TECHNICAL EVALUATION REPORT
SUSQUEHANNA STEAM ELECTRIC STATION
UNITS 1 & 2
STATION BLACKOUT EVALUATION

TAC Nos. 68613, 68614

Final
October 1, 1991

U.S. Nuclear Regulatory Commission
Washington, D.C. 20555

Figure 1: Susquahanna Units 1 and 2 Electrical Schematic

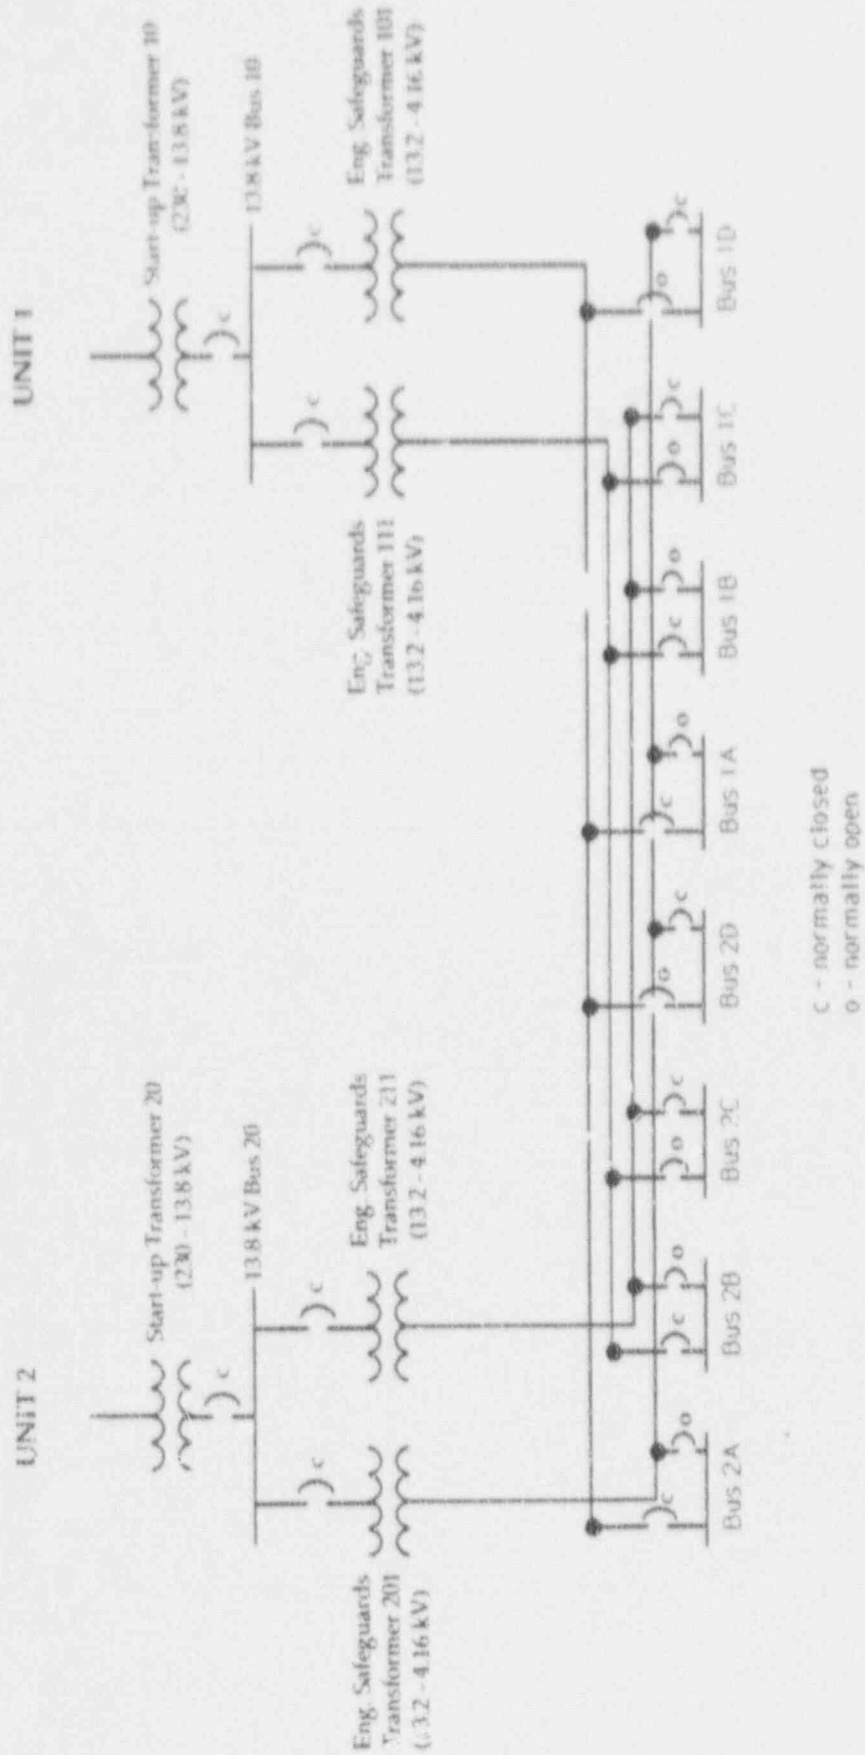
The licensee stated that the independence of offsite power system grouping is "11/2." A review of the Susquehanna FSAR (12) shows that:

1. There are two electrically connected switchyards for the site;
2. During normal plant operation, each unit's emergency busses are powered from two 230 kV offsite power sources through the start-up transformers (SUTs), as depicted in Figure 1;
3. Each SUT feeds two engineering safeguards transformers (ESTs);
4. Each EST is connectable to four emergency busses in both units, two of which are normally connected;
5. Upon a loss of power from one of the SUTs, the effected emergency busses will automatically be powered by the second SUT from automatic transfers at the 4.16 kV emergency bus level (see Figure 1).

Based on the above, the plant independence of offsite power system group is "12." This determination is based on the guidance of Table 5 of RG 1.155.
